**KAHLE LAKE DAM**

NDI No. PA 00825  
PennDER No. 61-20

**PHASE I INSPECTION REPORT**  
**NATIONAL DAM INSPECTION PROGRAM**

AUGUST 1979

**PHOTO 7. Concrete Weir Section of Auxiliary Spillway**

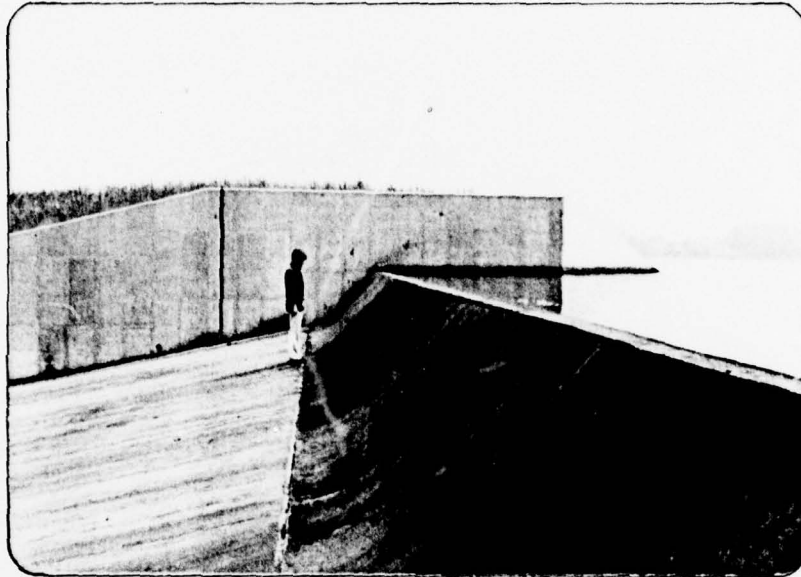
The auxiliary spillway was observed to be in good overall condition with only minor deficiencies. A portion of the joint sealer at the base of the overflow weir was missing. Minor cracking was noted along the walls of the concrete chute. Several weep holes in the stilling basin were plugged.

VISUAL EXAMINATION OF	OBSERVATIONS	REMARKS OR RECOMMENDATIONS
CONCRETE WEIR	<ol style="list-style-type: none"> <li>Concrete was in good overall condition. The joint sealer is missing at the base of the ogee section.</li> <li>Some minor cracking was noted along the walls of the concrete chute.</li> </ol>	<ol style="list-style-type: none"> <li>Recommend replacing the joint sealer.</li> <li>The cracking should be repaired, as necessary.</li> </ol>
APPROACH CHANNEL	Not Applicable	
DISCHARGE CHANNEL	<ol style="list-style-type: none"> <li>The discharge channel below the end sill is 150 ft. long and 44 ft. wide. The channel floor is grass-lined except for the center 20 ft. which has a gabion lining. The side slopes are 1H:1V and are covered with riprap. At the end of the lined channel is a 4.5 ft. high gabion wall with a small break near the right end to allow for passage of fish.</li> </ol>	<ol style="list-style-type: none"> <li>No action necessary.</li> </ol>

- 1) Regrade, treat, and seed the erosion channel on the downstream slope.
- 2) Institute a program to monitor the quantity and turbidity of the water within the marshy area.
- 3) Repair the cracks in the walls of the outlet discharge basin and the concrete chute below the auxiliary spillway.
- 4) Regrade the area on the right side of the outlet channel where the riprap has been undercut.
- 5) Regrade the low areas along the crest of the dam.
- 6) Clear the weep holes in the stilling basin.
- 7) Replace the joint filler where missing along the base of the overflow weir in the spillway.

**PHOTO 8. View of Stilling Basin and Concrete Chute Looking Downstream**

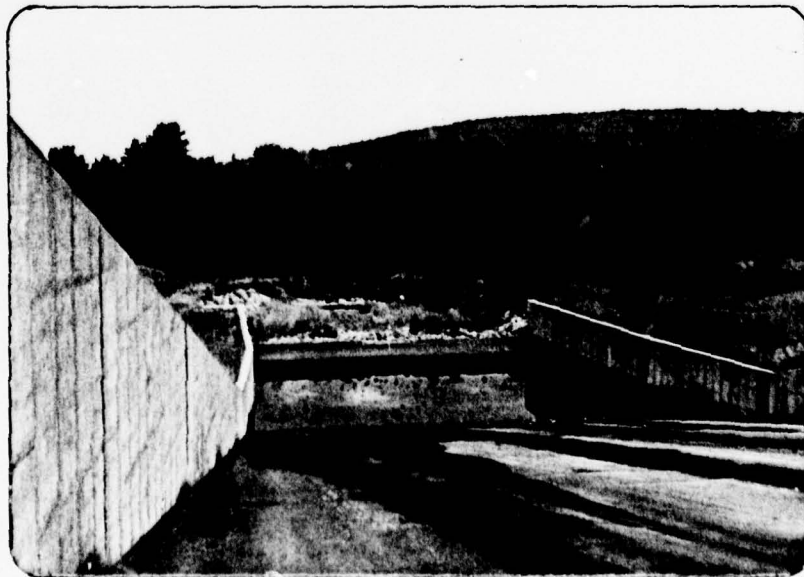
BRIDGE AND PIERS	None	<ol style="list-style-type: none"> <li>The weep holes should be unplugged.</li> </ol>

- 5) Regrade the low areas along the crest of the dam.
- 6) Clear the weep holes in the stilling basin.
- 7) Replace the joint filler where missing along the base of the overflow weir in the spillway.
